HOWARD COUNTY HISTORIC PRESERVATION COMMISSION

February Minutes

Thursday, February 2, 2017; 7:00 p.m.

Figure 3 - Proposed alterations

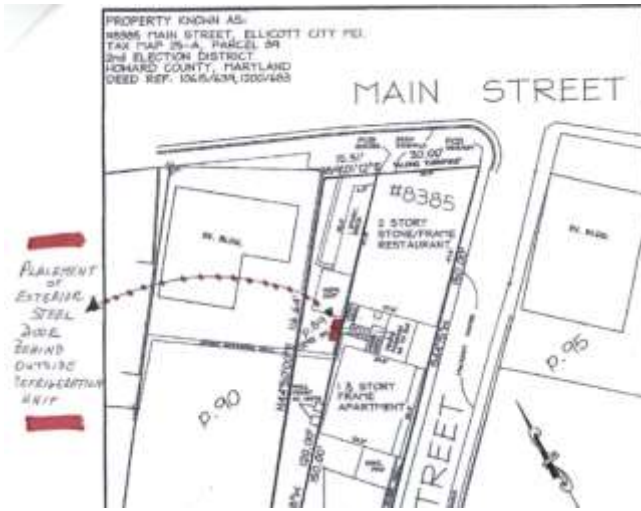
Staff Comments: These alterations will be taking place on the rear of the building in an area that is not visible from the public right of way and is only visible from the rear of the neighboring property. Chapter 6.G of the Guidelines states, “many historical buildings have secondary entrances not visible from streets or other properties. Where these entrances already have a modern replacement door, a new door does not necessarily need to be of a historically appropriate style.” Chapter 6.G (page 38) also recommends against, “cutting a new entrance into a primary façade or in any location where it destroys historic features important to the building’s character.” This building does not already have a modern replacement door, but it does have mechanical and other modern equipment necessary for the operation of the business. The rear of the building is not a character defining façade of the building. The installation of the door will not impair the integrity of the building or surrounding historic buildings.

Staff Recommendation: Staff recommends approval as submitted with the January 20th revision for the door to be a 6-panel embossed steel door.

Motion: Mr. Roth moved to approve the application as submitted with the January 20th revision of a 6-panel embossed steel door. Mr. Reich seconded. The motion was unanimously approved.

Figure 8 - Proposed projecting sign

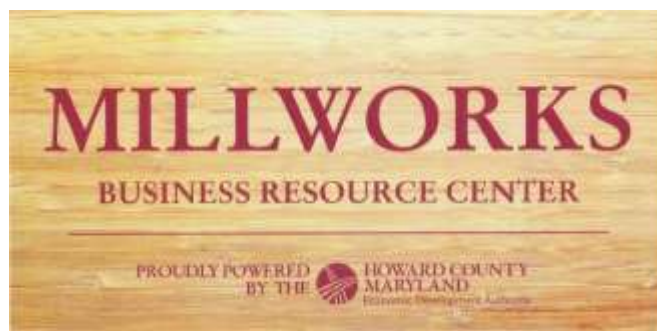
Staff recommends a border be added to the signs, in order to give them a finished appearance. Additionally, Staff recommends removing the parenthesis from the area code in the phone number. Staff understand the need to have hours of operation information at a pedestrian height and recommends the number of flat mounted signs be reduced to one sign, which better complies with the Guidelines.

Mr. Shad found the signs were really four signs because the hanging sign had two sides. He found the hanging sign is sufficient and that the information about operations can be placed inside the alcove. He said one panel sign would be enough. Mr. Thompson asked the Commission to clarify where the alcove is. Mr. Shad said the alcove is the recessed area above the entrance steps about three feet deep. Mr. Thompson said that area makes it hard for visitors to see the business hours. Ms. Tennor said the projecting sign is sufficient for directional purposes. Mr. Taylor asked Mr. Thompson which signs he would prefer if only two signs are approved. Mr. Thompson said he prefers the one projecting and one wall mounted sign.

- 1) Approval of the projecting sign, with a border added around the perimeter of the sign.
- 2) Approval of one flat mounted sign to be placed to the side of the door as proposed, with a border added around the perimeter of the sign and the parenthesis removed from the phone number.

Figure 10 - Proposed flat mounted sign

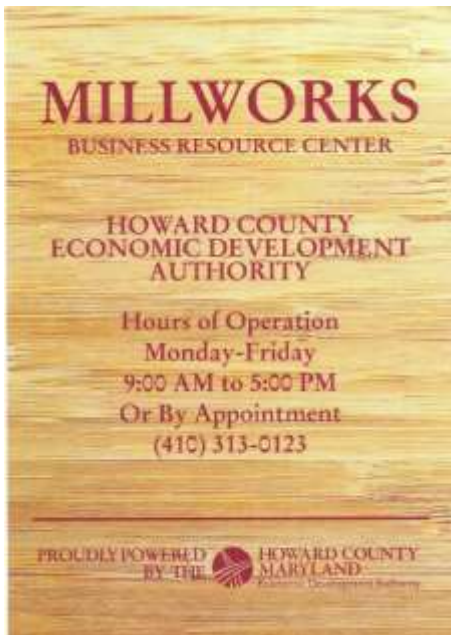
The Guidelines recommend against, “two signs where one is sufficient to provide an easily visible identification of the business” and “more than two signs per business per façade.” The smaller flat

mounted signs contain the hours of operation for the building and serve to give symmetry to the building. This building was constructed in the Greek Revival style and symmetry plays an important role in the details of this style. Similar symmetrical signs were approved for the Howard County Visitor's Center, as shown in Figure 11.

Ms. Zoren said the wall mounted sign is appropriate but it sets the precedent for others to have two signs. She recommends approving the hanging sign and one wall mounted sign with the business hours, which is sufficient and will not impact the visual symmetry. Ms. Zoren said the design of the sign is informal for the building's architecture and suggested adding a border around the sign. Mr. Reich asked about the sign guidelines and number of signs. Mr. Taylor said the Guidelines recommend against two signs where one is sufficient and recommend against more than two signs per business per façade.

Motion: Mr. Reich moved to approve the application per the Staff recommendations. Ms. Zoren seconded. Ms. Tennor and Mr. Roth opposed. The motion was approved 3 to 2.

Figure 18 - Aerial of site

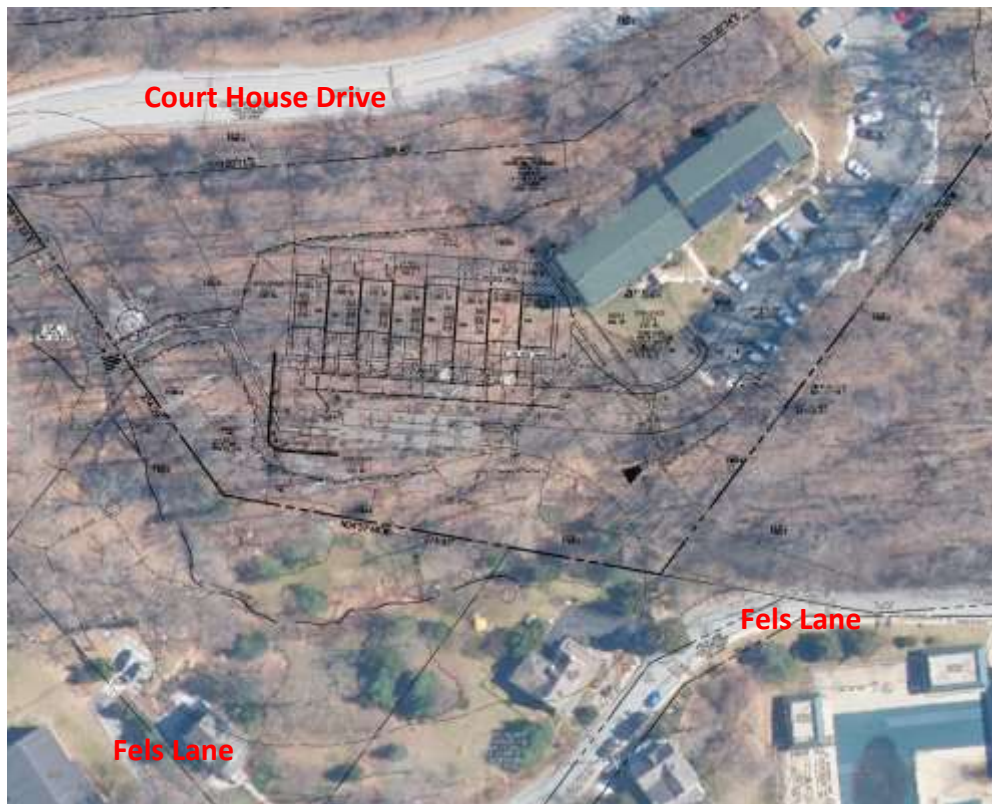
The site plan shows a garage for each townhouse. These garages will most likely be located on the front of the building, as there does not appear to be any access provided on the rear. Staff recommends the Applicant consider a rear loading garage as front loading garages are not common in the District. Chapter 7.C states, “new garages and sheds should follow the historic pattern of being detached from the main building and if practical, located in a side or rear yard.”

Figure 20 - Proposed dimensions

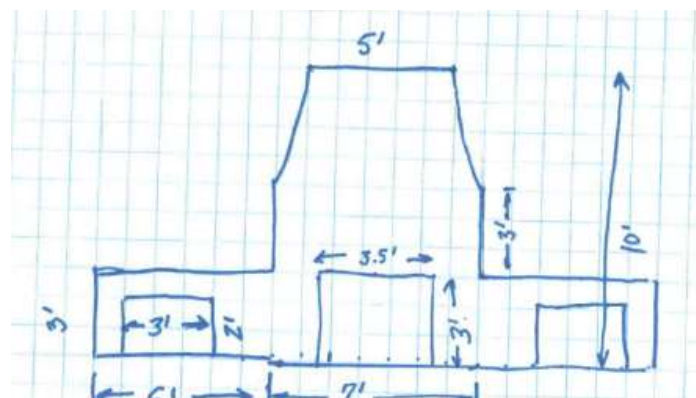
Staff Comments: The dimensions of the fireplace appear proportionate. The materials comply with Chapter 9.D of the Guidelines (page 70) and will match other stonework in the direct vicinity, “construct new site features using materials compatible with the setting and with nearby historic structures, particularly for features visible from a public way.”

Ms. Zoren said the plans show the fireboxes being 27 inches deep but if it is used for storage with a back to it, it needs to be more than a foot thick. Mr. Reich said with an existing wall, it will not be enough for a 27 inch depth. Ms. Kehoe said the back wall is existing. Mr. Reich said the alcove will need to be at least 2 feet deep in order to store wood in there. Ms. Tennor said that 10 feet tall is a commanding height but that it will be outside and not seem that large. Mr. Reich said the existing wall is about 4 feet high, so this will not seem out of place. Ms. Zoren asked if the back side of the fireplace will be stone. Ms. Kehoe said yes, the side facing Lot D will be all stone.

Figure 34 - Proposed location of retaining wall

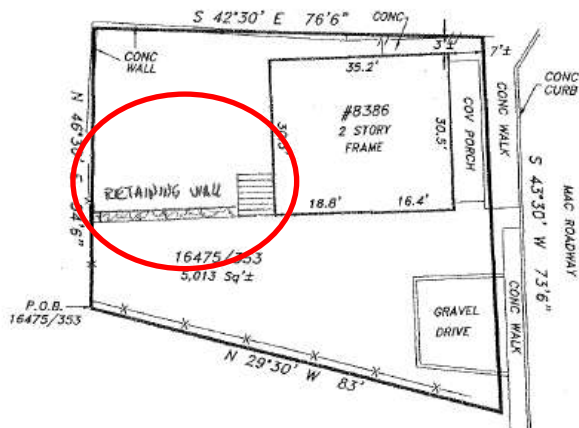
The Applicant also proposes to install a 36 foot long retaining wall that will be 3.6 feet (44 inches) high. Steps will be built adjacent to the rear porch, allowing access through the retaining wall from one side of the yard to the other. The Applicant proposes to construct the retaining wall and steps out of Allan Block. A black metal railing will be installed on top of the retaining wall and will be 3.75 feet (45 inches) high. The description of work in the application also references timber as a retaining wall option.

Testimony: Mr. Shad swore in Mr. Reinaldo Velazquez. Mr. Shad asked if there were any additions or corrections to the Staff comments or application. Mr. Velazquez said he is withdrawing the retaining wall approval request, and is seeking approval for replacement of the property fence, the rear porch design and replacing the existing rear porch. Ms. Holmes asked if the Applicant wants the back door to match the front wood door, which is a 1 light over 2 panel door. Mr. Velazquez said yes. Ms. Tennor asked if the fence will replace the existing chain link fence. Mr. Velazquez said yes, it will be painted white with no gates.

Figure 39 - November 2016 conditions

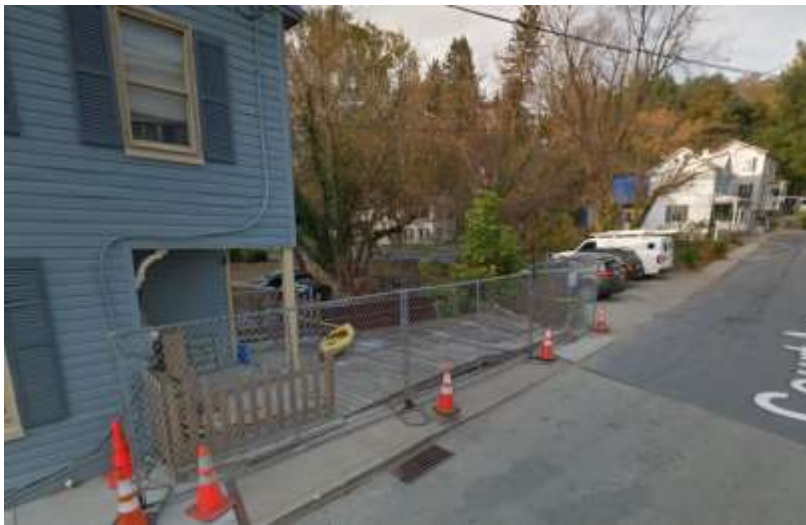
Mr. Reich asked if there is rip rap at the bottom of the stream channel wall. Mr. DeLuca said no, not at the section that Mr. Reich referred to on the drawing, it will be stone all the way down to the stream. He said that rip rap will be installed in a small center section. Mr. Reich pointed out the symbol for rip rap installation on the plan drawings. Mr. DeLuca said it may not be shown correctly.

Mr. Reich asked if the old stones will be removed and new stones will be installed. Mr. DeLuca said new stone will be added to the existing stones, then the remaining wall elevation will be built up with new

Mr. DeLuca said there is one section of the stream channel (shaded green on the plans) that did not previously have a wall. He explained that DPW will be using anchored geo-webbing and landscaping to restore this section and the area at the base of the wall where it meets the stream will be armored with stone. A section of the wall will be concrete, because it will be part of the culvert parallel to Court Avenue where there are structured supports on the other side near the Sunflower Seed Company to support their deck.

stone. Mr. DeLuca pointed to a wall section behind the building at Court Avenue and Main Street where it is currently a composite material, but all failing due to July's storm. He explained that the beams were bearing on the stream wall and extended several feet inside the building. DPW had to remove the beams as emergency repairs after the storm in order to keep the building from getting damaged in anticipation of the wall failing. Mr. Reich asked if the new wall will be exposed concrete or faced with a stone. Mr. DeLuca said facing is a possibility and it is currently in the contract to use the stone in six inch veneer but it will not be stacked stone like the rest of the project. Mr. Reich said he found the stone appearance was important even if it was different. He recommended stone be applied whenever there is exposed concrete. Mr. DeLuca said that visibility depends on where you stand right now, because this area is underneath the bridge. Mr. DeLuca said that the view of this wall from the path from Court Avenue to Parking Lot F will be of stone.
